2007 - 2013 Corvette: GM TechLink: Low Oil Pressure on V8 Engines

Subject: Low Oil Pressure on V8 Engines

Model and Year: 2007 - 2013 CTS-V, Escalade, Avalanche, Camaro SS, Colorado, Corvette, Express, Silverado, Suburban, Tahoe, Canyon, Sierra, Savana, and Yukon models equipped with a V8 engine (RPOs L20, L77, L94, L96, L99, L9H, LC8, LC9, LH9, LMF, LMG, LY6, LZ1)

Source: GM TechLink

Fig. 3

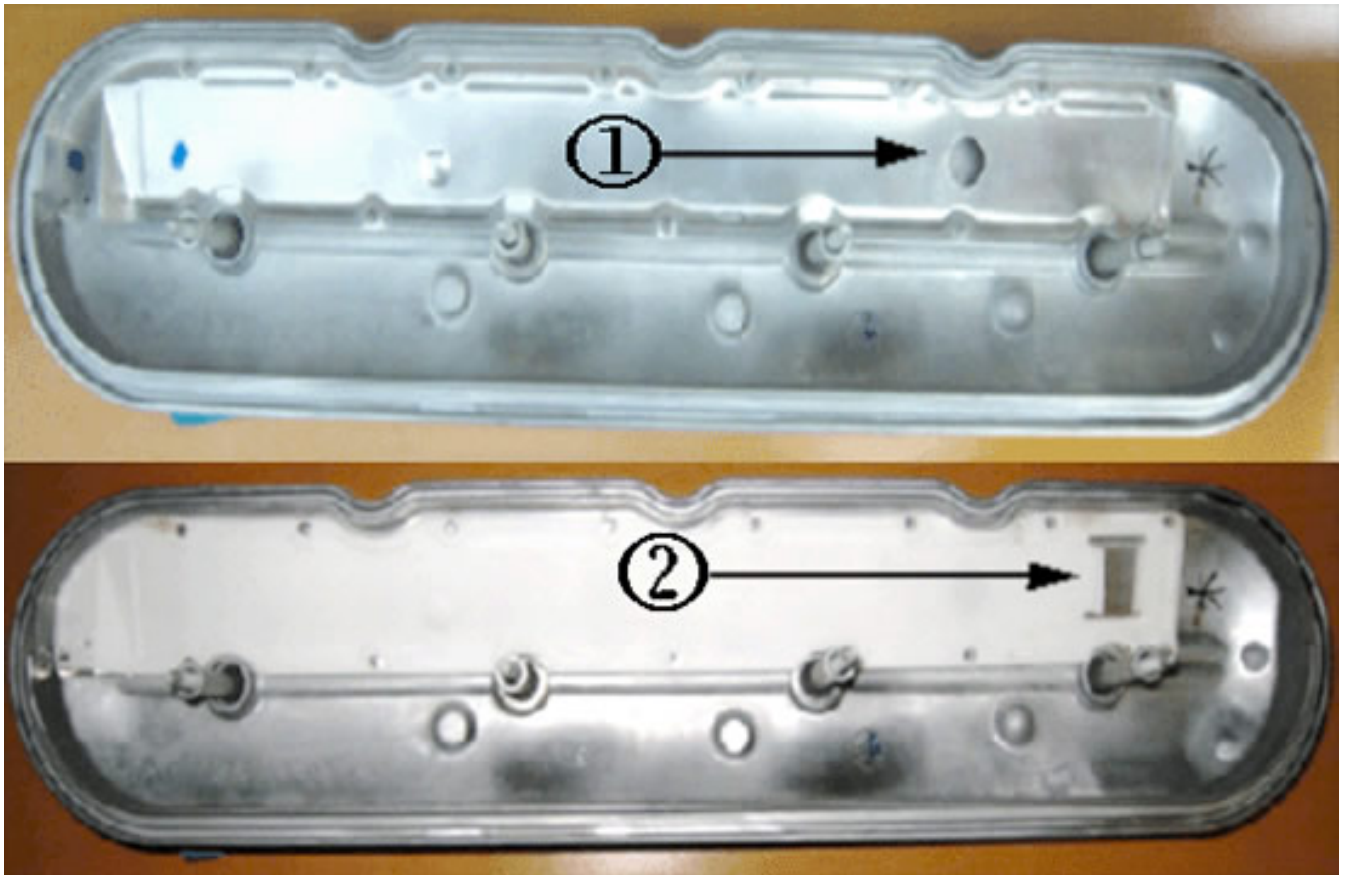
If the engine has been properly repaired and cleaned, inspect the left rocker cover (square baffle) (Fig. 3, #1 – old design; #2 – new design with square baffle) and verify that the baffles can hold water and do not leak. If any leaks

are found, clean and seal the edge of the baffle with RTV, if possible, or replace the valve cover. Thoroughly clean and dry the valve cover before installation and/or resealing.
